Re: PETITION NO. 1442 - SR Litchfield, LLC petition for a declaratory ruling, pursuant to Connecticut General Statutes §4-176 and §16-50k, for the proposed construction, maintenance and operation of a 19.8-megawatt AC solar photovoltaic electric generating facility on 6 contiguous parcels located both east and west of Wilson Road south of the intersection with Litchfield Town Farm Road in Litchfield, Connecticut, and both east and west of Rossi Road, south of the intersection with Highland Avenue in Torrington, Connecticut, and associated electrical interconnection

SR Litchfield, LLC hereby submits a revised Preliminary Site Layout Plan (Petition Exhibit A (rev. 05.03.21)) and a map illustrating the modifications made to the original Project design (Exhibit 1: Overall Site Plan) in connection with the above-referenced Petition.

Enclosures (revised Preliminary Site Layout Plan (Petition Exhibit A (rev. 05.03.21) and a map illustrating the modifications made to the original Project design (Exhibit 1; Overall Site Plan (05.12.21)))

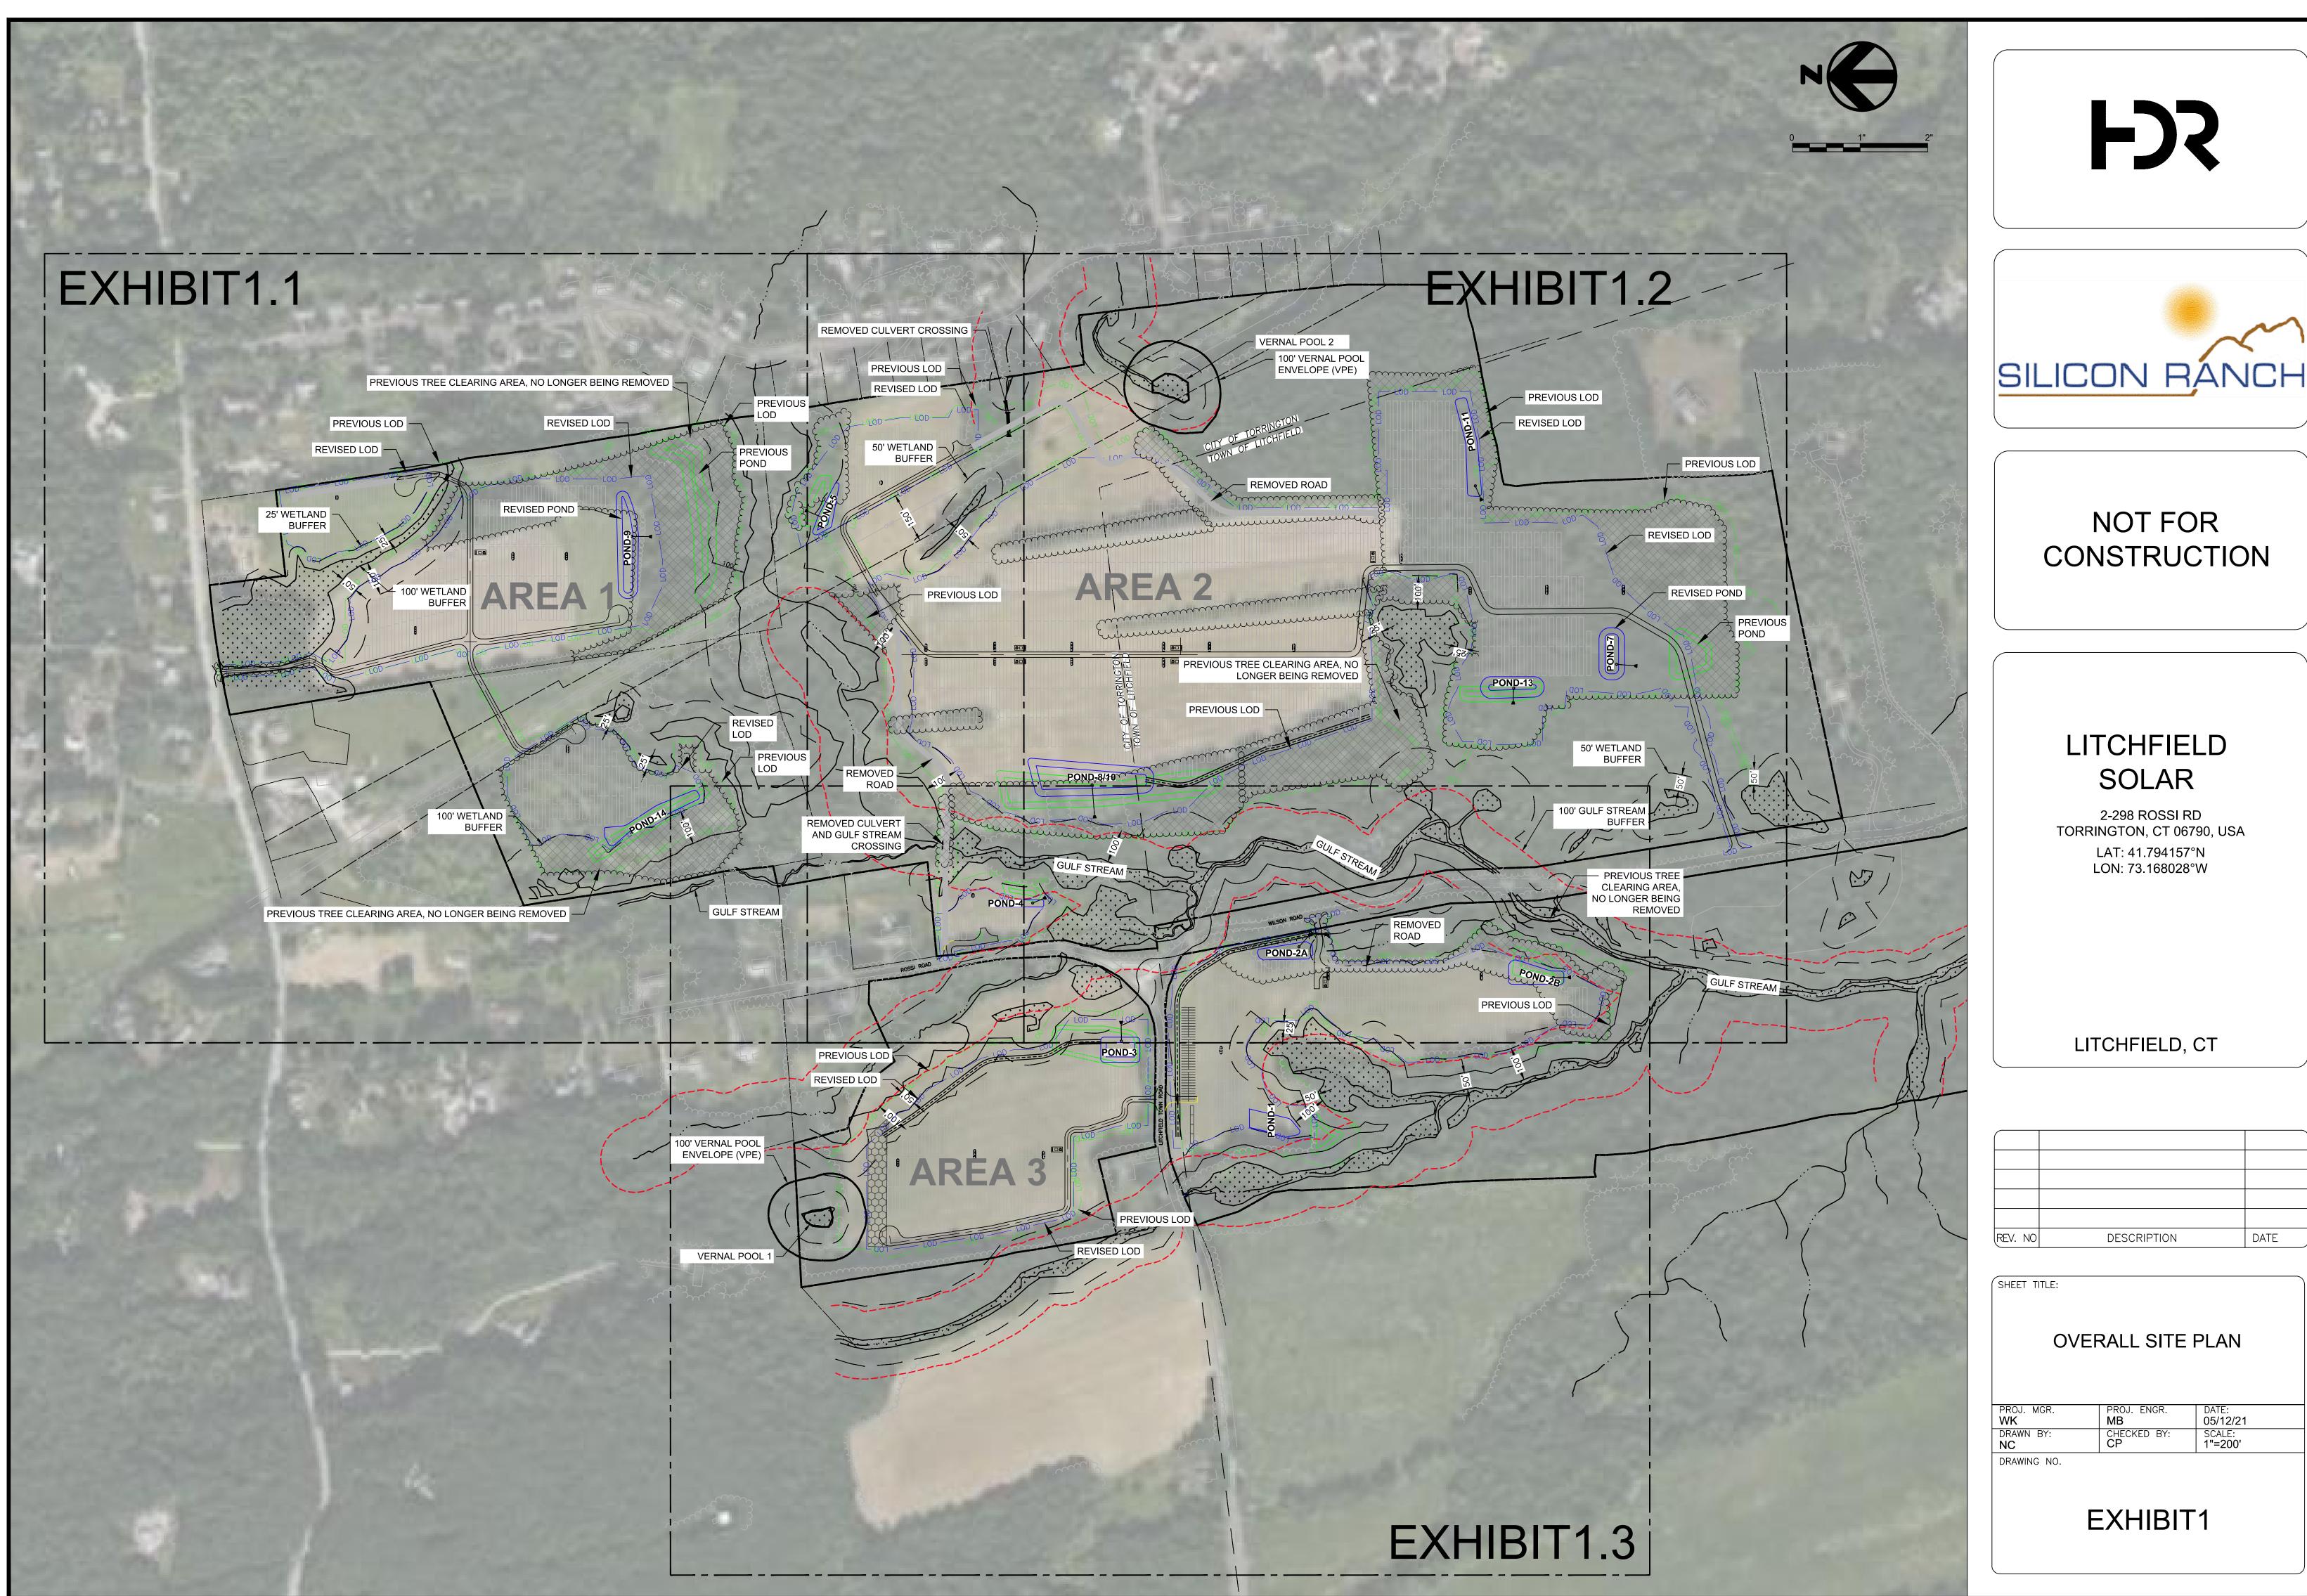
Starting at the access roadway off Highland Avenue to the north, this existing access driveway will now be used to access the Project's northern-most array fields. This access roadway will be narrowed to twelve feet (12'), narrower than SR Litchfield would typically construct, to reduce wetland impacts. Retention walls (gabion blocks) will be used to support this access driveway and further minimize the impact on the wetland. This approach is partially responsible for the reduction in a more than fifty percent (50%) overall reduction in wetland disturbance between the original Project design and the redesigned Project.

Next, turning to the area east of the Eversource transmission line easement and west of the properties along Wimbledon Gate North, several rows of solar modules were eliminated from the Project design. These modules had been located to the south. By removing these modules, a considerable amount of earth-work and grading was eliminated. Additionally, the Limit of Disturbance was retracted considerably in this area resulting in a significant reduction in the amount of tree clearing, contributing to the more than sixty-two percent (62%) overall reduction in tree clearing from the original Project design. Furthermore, Stormwater Pond 9 was reduced in size and moved to the north and off of the steeper slopes. These changes also increased the distance between any development activity the Wimbledon Gate North residences to the east.

Similar modifications were also made in the area to the west of the Eversource transmission line easement and east of Gulf Stream. Stormwater Pond 14 was reduced in size and the discharge towards Gulf Stream was eliminated. The Limit of Disturbance was contracted substantially in this area. A significant level of tree clearing was also eliminated. These modifications increased the buffer in this area between development activity and the Gulf Stream riparian corridor to a minimum of one hundred feet (100').

Starting with the small solar array directly east of Rossi Road and north of the intersection with Town Farm Road, Stormwater Pond 4 and its discharge point were moved outside of the one hundred-foot (100') buffer from Gulf Stream. These modifications eliminated all development activity in this area from the one hundred food (100') Gulf Stream riparian corridor.

Further, the access roadway from Rossi Road was eliminated and replaced with a smaller Site entrance driveway added perpendicular to Rossi Road. The elimination of this access roadway eliminates the crossing of Gulf Stream and the need to install a culvert over Gulf Stream. This modification significantly reduced wetland impacts and preserved Gulf Stream in its current state. It also eliminated a sizable amount of roadway on the east side of Gulf Stream. By removing this roadway, the Limit of Disturbance in this area was reduced and brought outside the one hundred foot (100') Gulf Stream buffer.

The redesign also eliminated the underground electric line that would have extended from the solar array east of Rossi Road to the solar array south of Town Farm Road and would have traversed a wetland and a tributary of Gulf Stream. Instead, if this electric line is necessary, it would now be placed overhead. The overhead electric line would have a clear span over Gulf Stream and the bordering wetlands in order to avoid any direct impact within Gulf Stream and the one hundred foot (100') Gulf Stream buffer. This overhead line would also be positioned along the existing farm road that crosses Gulf Stream, an area that is already cleared of vegetation, to avoid the need for any additional tree or vegetation clearing within or bordering Gulf Stream, thereby eliminating any direct or indirect impacts.

Moving to the area east of Gulf Stream, the laydown area east of Stormwater Pond 8/10 was eliminated. Stormwater Pond 8/10 was also substantially reduced in size, moved to the east and away from Gulf Stream, and its discharge point was moved outside the one hundred foot (100') Gulf Stream buffer. In general, the Limit of Disturbance in this area was reduced considerable. This resulted in a sizable reduction in tree clearing along the east side of the Gulf Stream riparian corridor.

In the small area to the east of the Eversource transmission line easement, south of Stormwater Pond 5, and west of the Site boundary, the internal access roadway was eliminated. This allowed the Limit of Disturbance in this area to be reduced to a location more than one hundred feet (100') from the wetlands in the area of Vernal Pool 2. The elimination of the roadway in this area also eliminated another culvert crossing.

Continuing south along the eastern property border, Stormwater Pond 11 was modified to move the discharge point from the southeast corner to the southwest corner. This modification was made after several discussions with the adjacent property owner (68 Wilson Road). The goal of the change is to better manage the discharge and any stormwater runoff from affecting the adjacent property owner's property. While SR Litchfield and its consultants were confident that the prior design of Stormwater Pond 11 did not pose a risk to the adjoining property, it nevertheless undertook to address the owner's concerns.

Similarly, the Limit of Disturbance along the property line with 68, 84, and 86 Wilson Road was significantly reduced; in many places the limits of disturbance were reduced by more than one hundred feet (100'). This not only will reduce the tree clearing in this area, but it will preserve a natural buffer with these adjoining properties. To achieve this reduction in the Limit of Disturbance in this area, several rows of modules on steep slopes near Stormwater Pond 7 were eliminated. Allowing a sizeable reduction in grading in this area. Stormwater Pond 7 was also redesigned and moved north. The discharge point for Stormwater Pond 7 was also modified and it no longer has a direct discharge into wetlands.

Perhaps one of the more significant additions to the Project design was the addition of an access roadway from east side of Wilson Road. This access roadway is a replacement for the access driveway that previously crossed Gulf Stream. SR Litchfield seriously considered the Council's Interrogatory No. 48 and conducted a comprehensive evaluation of the Council's suggested approach. While the new access roadway will have grades up to twenty percent (20%), require cut and fill slopes in previously undisturbed and forested areas, and will result in a Limit of Disturbance (a roadway) that is fifty feet (50') from two separate wetlands, SR Litchfield agreed with the Council that when compared with the impacts the former access roadway would have to

Moving west of Wilson Road, the access roadway on the west side of Wilson Road was eliminated. Stormwater Pond 2 was also changed to two (2) separate ponds – Pond 2A and Pond 2B. These two changes allowed the Limit of Disturbance to be reduced, a sizeable amount of tree clearing to be eliminated, and Stormwater Pond 2B to be moved outside of the one hundred foot (100') Gulf Stream buffer. In addition, Stormwater Pond 2B (formerly Pond 2) no longer has a direct discharge to Gulf Stream.

Moving north, Stormwater Pond 1 was similarly modified and moved north out of the one hundred foot (100') buffer for a tributary of Gulf Stream and more than one hundred feet (100') from the nearest wetland. Similarly, the Limit of Disturbance was also moved outside of these buffers to once again draw development activity away from wetlands and watercourses and reduce the need for grading and tree clearing.

In the area north of Town Farm Road and west of Rossi Road, Stormwater Pond 3 was reduced in size substantially, resulting in the Limit of Disturbance in this area being reduced and removed from the one hundred foot (100') buffer for a tributary of Gulf Stream. This also provided a larger buffer between the wetlands in this area and development activity. In fact, the Limit of Disturbance around the entire solar array field in this area was reduced. Thus, moving development activity further away from neighboring properties and away from wetlands and watercourses.

Importantly, the laydown area in the northern portion of this array was moved to the south. This places the laydown area outside the one hundred foot (100') vernal pool envelope (VPE) for Vernal Pool 1. This change is in direct response to the Council's inquiry in Interrogatory No. 59. With this change, there will be no permanent or temporary disturbances within the VPE for either Vernal Pool 1 or Vernal Pool 2.
